Project	IEEE 802.16 Broadband Wireless Access Working Group < http://ieee802.org/16 >	
Title	Text proposal for MAC handover cases procedure in an MR Network	
Date Submitted	2006-11-16	
Source(s)	<p>Hyunjeong Lee hyunjeong.hannah.lee@intel.com Wendy C. Wong Jerry Sydir Kerstin Johnsson Intel Corporation</p> <p>Hyunjeong Kang hyunjeong.kang@samsung.com Hyoung Kyu Lim Rakesh Taori Samsung Electronics</p> <p>Kenji Saito saito@kddilabs.jp KDDI R&D Lab Inc.</p> <p>Gang Shen gang.a.shen@alcatel-sbell.com.cn Kaibin Zhang Alcatel, Research & Innovation</p>	<p>Sujean Yang sujean35@ewhain.net Meejeong Lee lmj@ewha.ac.kr Dept. of Computer Science and Engineering Ewha Womans University</p> <p>Yousuf Saifullah yousuf.Saifullah@nokia.com Shashikant Maheshwari Haihong Zheng Nokia</p> <p>Sungkyung Kim cyrano@etri.re.kr Sungcheol Chang Chulsik Yoon ETRI</p>
Re:	Text change proposal for IEEE 802.16j amendment	
Abstract	This document defines seven handover cases in IEEE 802.16j MR networks.

2. Proposed text change

Figure 1 Seven Handover Cases in an MR network

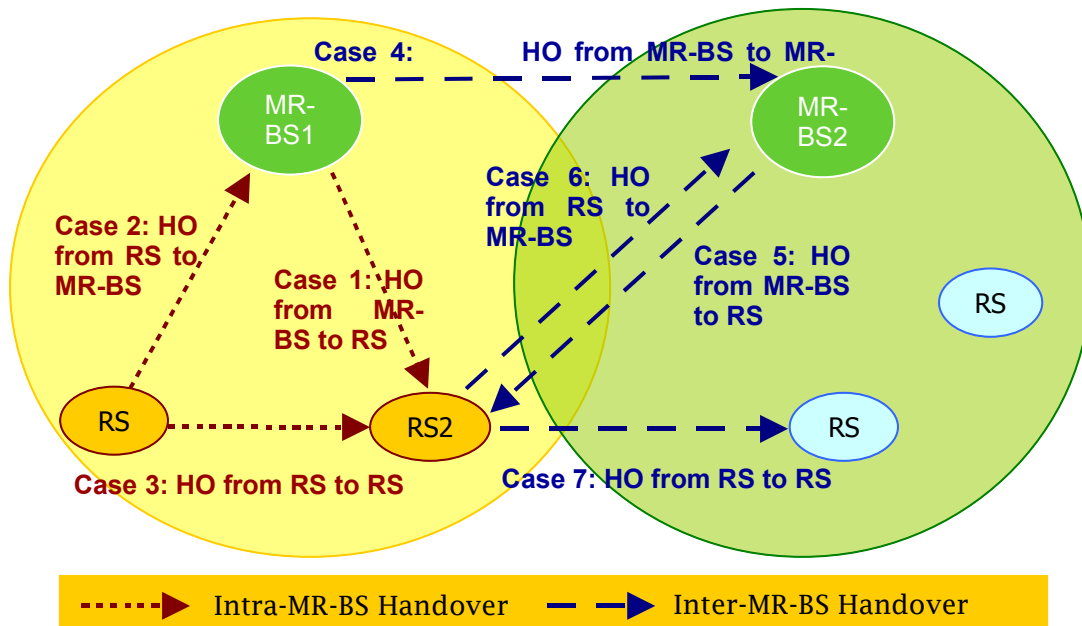
Due to the introduction of RSs into the network infrastructure, seven different handover cases illustrated in can occur in an MR network. The seven cases belong to two main categories of handover: (1) Intra MR-BS handover if the handover is between two RSs controlled by the same MR-BS or between an MR-BS and one of its subordinate RSs; and (2) Inter MR-BS handover if the handover is between two MR-BSs, two RSs each controlled by different MR-BSs, or between an MR-BS and an RS controlled by a different MR-BS.

~~All~~The six new cases (i.e., Cases 1, 2, 3, 5, 6, and 7) require signaling among involved RSs and MR-BSs to support handover. ~~Therefore, this subclause also~~ contains procedures for infrastructure stations to support MS handover if the MS is attached to an MR network.

The hHandover procedures for these cases shall accommodate various types of RSs of different capabilities depending on the functional split between MR-BS and its subordinate RSs.
